United States Patent and Trademark Office

APPLICATION NO.	FILING DATE	FIRST NAMED INVENTOR	ATTORNEY DOCKET NO.	CONFIRMATION NO.
10/525,731	02/28/2005	Jean-Marc Galewski	01435.0204	8298
22852	7590 10/23/200	. EXAMINER		
•	I, HENDERSON, F	BOYKIN, TERRESSA M		
LLP 901 NEW YORK AVENUE, NW			ART UNIT	PAPER NUMBER
	WASHINGTON, DC 20001-4413

Application No.	Applicant(s)			
Office Action Summary						
		10/525,731 Examiner	GALEWSKI ET AL. Art Unit			
		Terressa M. Boykin	1711			
	The MAILING DATE of this communication app					
Period for Reply						
WHIC - Exter after - If NC - Failu Any	ORTENED STATUTORY PERIOD FOR REPLY CHEVER IS LONGER, FROM THE MAILING DA nsions of time may be available under the provisions of 37 CFR 1.13 SIX (6) MONTHS from the mailing date of this communication. O period for reply is specified above, the maximum statutory period were to reply within the set or extended period for reply will, by statute, reply received by the Office later than three months after the mailing ed patent term adjustment. See 37 CFR 1.704(b).	ATE OF THIS COMMUNICATION 36(a). In no event, however, may a reply be tim vill apply and will expire SIX (6) MONTHS from cause the application to b

Figure 1 is a diagrammatic representation of the apparatus:

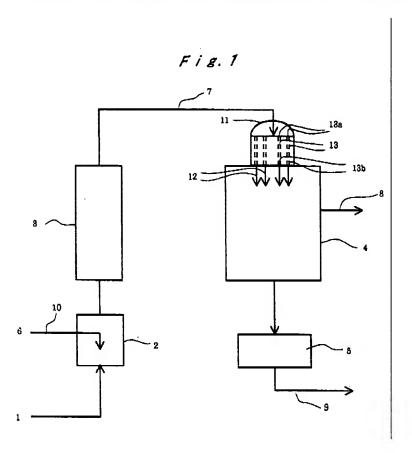
USP 6124426 (EP 0905149) discloses a Volatile residues up to 2 wt.% are removed from polymers by adding a blowing agent in such a way as to ensure good mixing with the polymer, mixing in a static mixing apparatus and extruding into a devolatilizing tank. Temperature and pressure of blowing are controlled by monitoring a control coefficient. The blowing agent is discharged in contraflow to the polymer and the mixture is passed through a static mixing apparatus at a temperature higher than the vaporization temperature of the blowing agent at normal pressure, but lower than the decomposition temperature of the polymer and at such a pressure as to prevent blowing. The mixture is then extruded vertically into a devolatilizing tank and the polymer made into a blown product at a temperature and pressure such that, as defined by the expression B = A'/A; wherein:

A = cross-sectional area of an opening in the extruder

A' = average cross-sectional area of the blown polymer composition perpendicular to the vertical direction of the blown polymer composition at the point 50-100 cm below the opening.

the blowing coefficient B is 1.4 or more.

The process is used for the removal of residual monomer and solvent from polymers. Using the method allows for the reduction of residual volatiles to 82 ppm or less. A devolatization pressure of 10 mmHg or more can be used which prevents freezing of the water during its recovery by condensation. Deterioration of the polymer can be prevented by the use of lower operating temperatures.
